# CITY OF ORLANDO

RE: Letter of Determination for Administrative Specific Parcel Master Plan for 478,400 sq. ft. Warehouse/Distribution Center, 3650 8<sup>th</sup> St./Express Ln., Orlando, FL (Phase 1 of Air Commerce Park PD, Parcel ID #05-24-30-0000-00-003) LDC2016-00037

### Proposed Site Plan

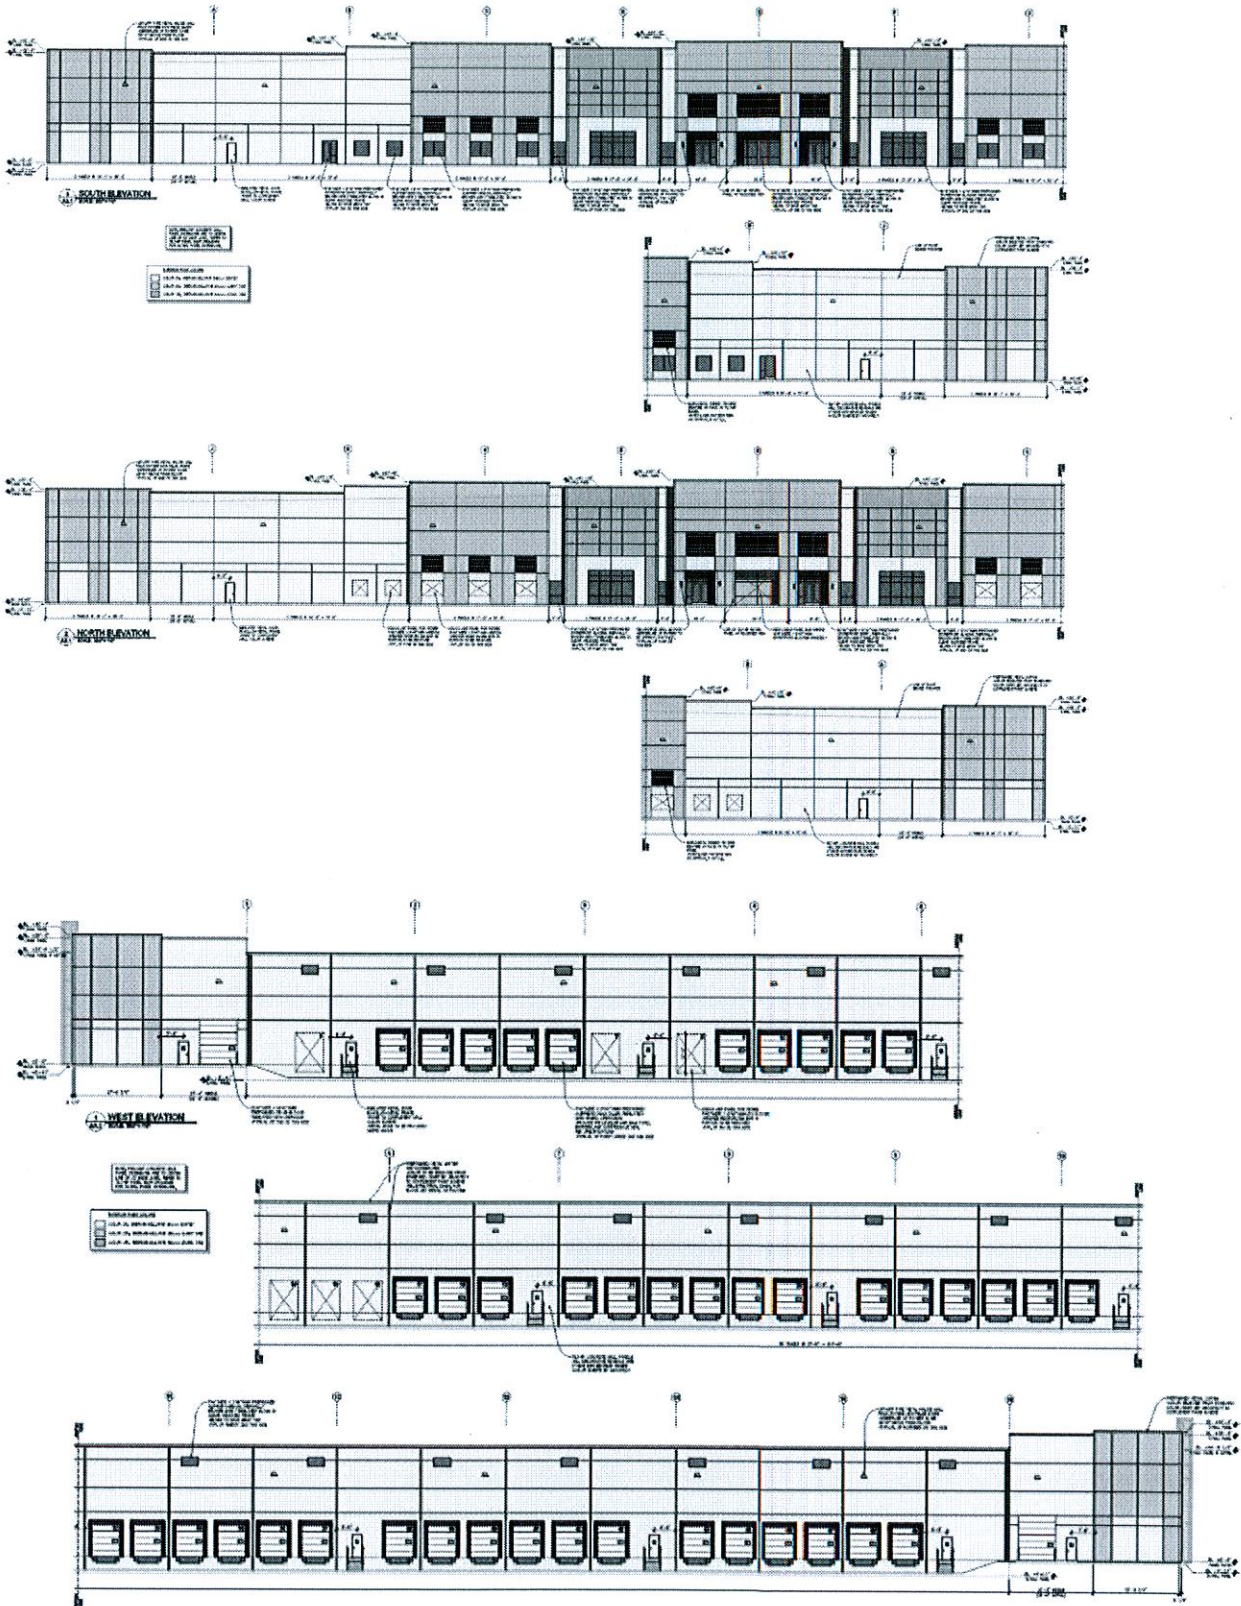
1. Note 3 under Access Drives shall be modified to read, "...The temporary access drive will be eliminated upon construction of the internal road first phase..."
2. The alignment of Segment 2 shall be modified so Segment 2 (Seven Seas Dr) has a continuous alignment and not two sharp 90 degree corners as shown in Figure B of ZON2015-00050.
3. References to Seven Seas Lane shall be changed to Seven Seas Drive.
4. A letter shall be provided from the gas line owner granting permission to build drive aisles and parking stalls above the existing gas line.
5. 8th St shall be improved per ZON2015-00050.
6. The sidewalk along 8th St shall extend the entire frontage of Tract A.
7. A pedestrian connection shall be provided from the internal sidewalk network to 8th St and the future Seven Seas Dr extension along the west property line.

8. Internal sidewalk network should connect the two main parking lots.
9. Drainage ditch realigned along west property line shall not impact the future Seven Seas Dr right-of-way.

10. Driveway stop lines shall be located before, not after, the crosswalk.
11. At all project entrances and at on-street parking spaces, clear sight distances for drivers and pedestrians shall not be blocked by signs, buildings, building columns, landscaping, or other visual impediments. No structure, fence, wall, or other visual impediment shall obstruct vision between 3 feet and 8 feet in height above street level. The street corner / driveway visibility area shall be shown and noted on construction plans and any future site plan submittals. The applicant shall design the site plan as necessary to comply with the Florida Greenbook and the FDOT Design Standards Index.

Elevations

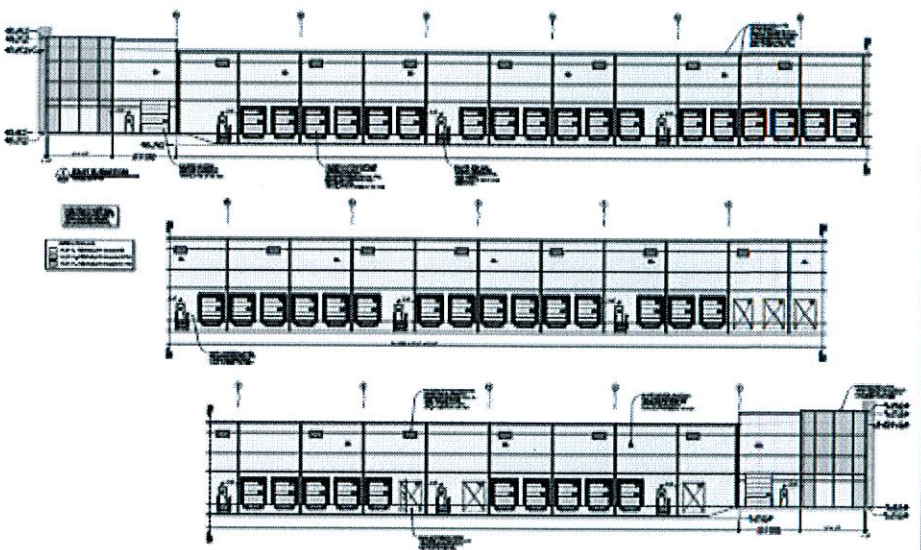
1. Add a watertable base, 3 to 5-ft. in height, of durable materials, all elevations.
2. Per the PD, the north and south elevations shall have 15% transparency in the first 10 feet above grade. Transparency requirements must be met with clear glass, or with low-e glass of at least 60% light transmittance.
3. Parapets must be of sufficient height to screen any rooftop HVAC equipment; OR HVAC equipment may be screened by structures such as louvered enclosures.
